UNITED STATES
DEPARTMENT OF THE INTERIOR
BUREAU OF LAND MANAGEMENT

FORM APPROVED
OMB NO. 1004-0135
Expires: July 31, 2010**SUNDRY NOTICES AND REPORTS ON WELLS**
*Do not use this form for proposals to drill or to re-enter an abandoned well. Use form 3160-3 (APD) for such proposals.***SUBMIT IN TRIPLICATE - Other instructions on reverse side.**

WELL NAME: Anemone ANE Federal #3 FIELD: East Indian Basin

Yates Petroleum Corporation
Anemone ANE Federal - 003
API 3001528126
March 29, 2012

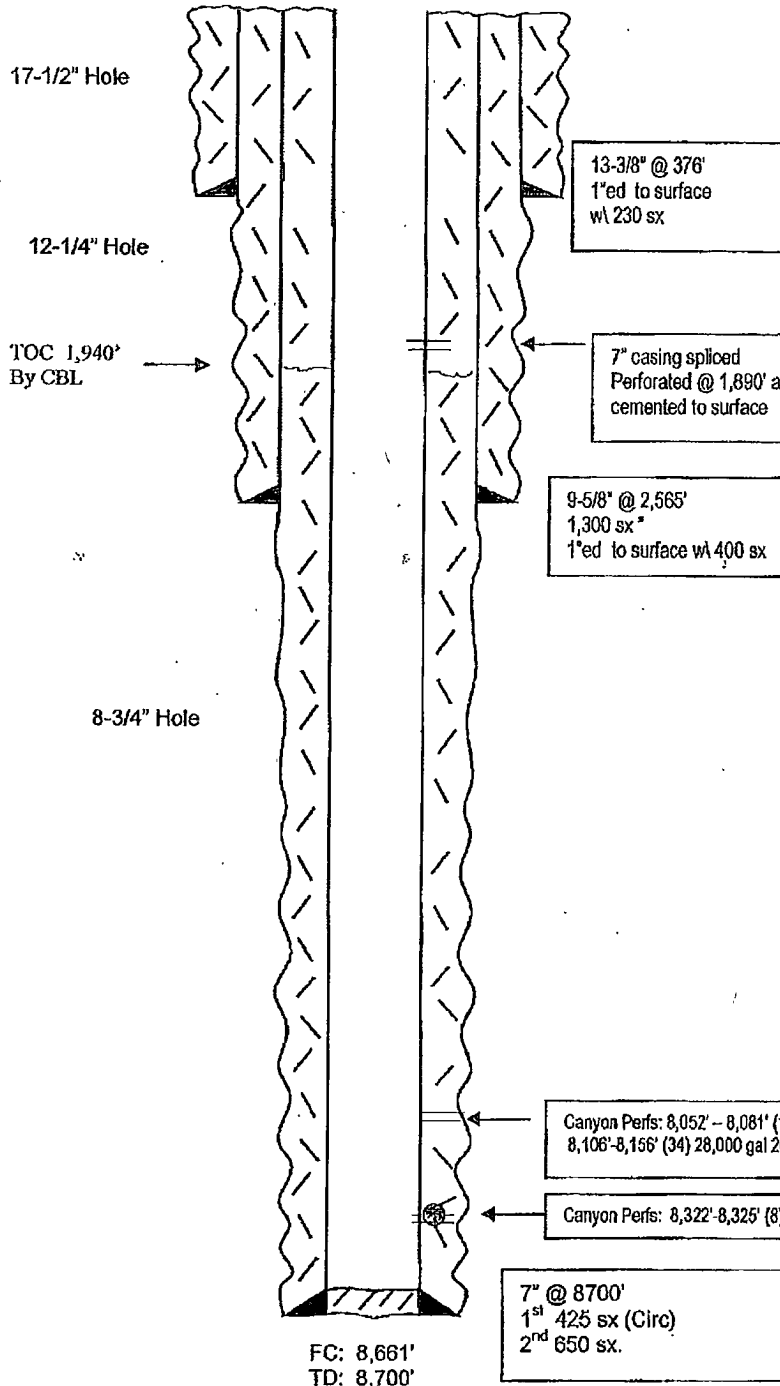
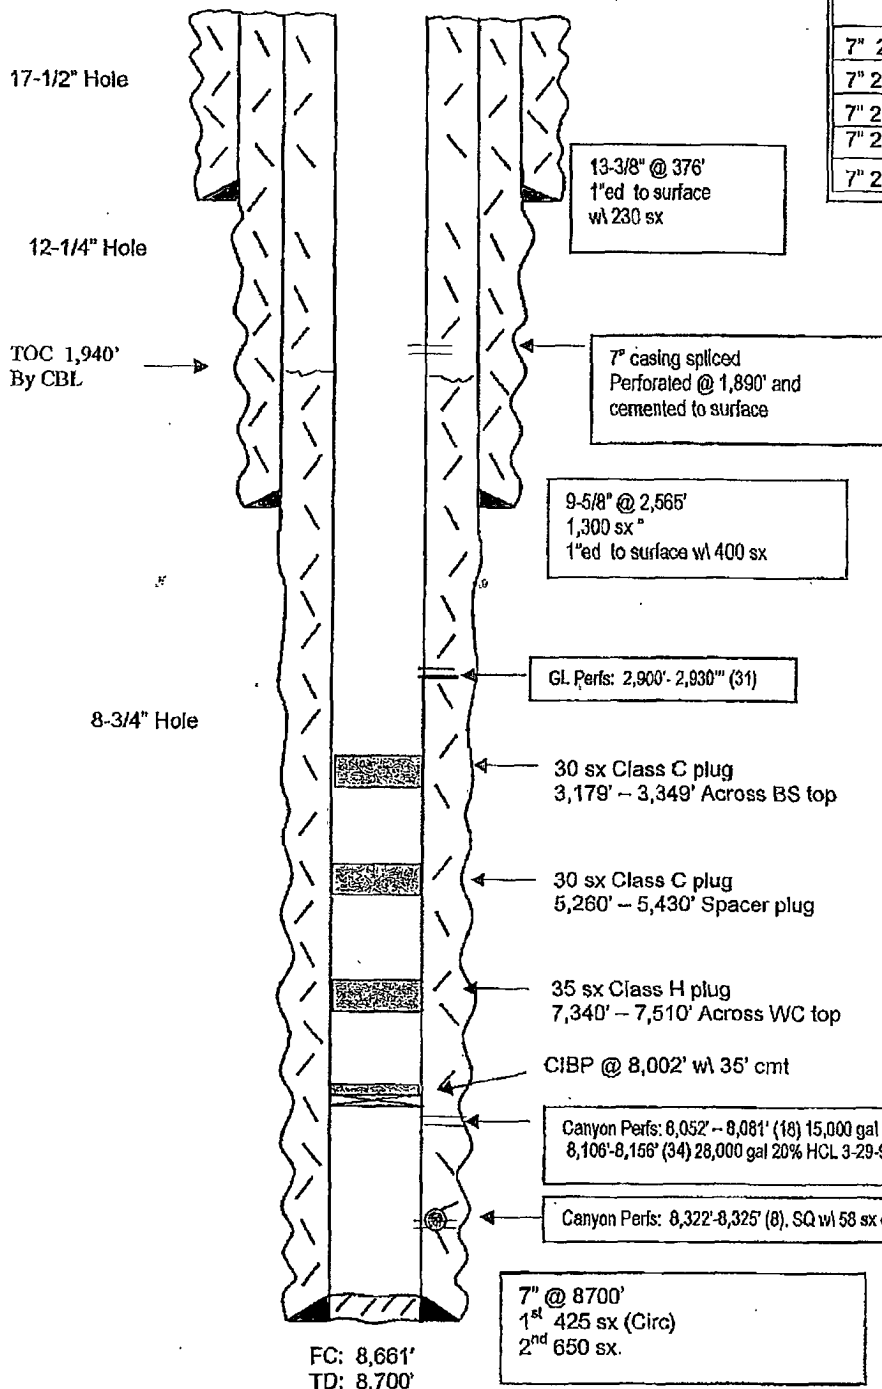
7. Provide BLM with an electronic (Adobe Acrobat Document) cement bond log record from the cement plug to be placed at 3179'-3349' or below to top of cement.

8. Minimum requirement for mud placed between plugs is 25 sacks of salt water gel per 100 barrels of 9 lb/gal brine.
9. Set the CIBP at 8002'. Tag the CIBP at 8002' and place a Class H 25sx cement plug on that CIBP.

10. Set Wolfcamp plug as proposed.
11. A Class C cement plug (35sx minimum) is to be placed from 6600' and cover the DV Tool reported at 6521' by at least 50ft. Tag the plug at 6470' or shallower.

12. Set remaining plugs as proposed, using 30 sacks of Class C for the cement plug from 5430'.
13. The 7" 23# J55 LT&C csg reported set from 3854' to 7167' has a 100% burst rating of 4360 psig and collapse of 3270 psig new. This office would not have approved its use. The proposed perforations are to be in this segment.

14. Operator to test casing to 3000 psi prior to frac treatment.
15. Operator shall also perform a pressure test after the frac treatment to verify that casing integrity has been maintained. This pressure test shall be the maximum pressure reached during the fracture treatment, but not less than 2500 psi and can be performed after frac fluids flow back. Both pressure tests to be charted.
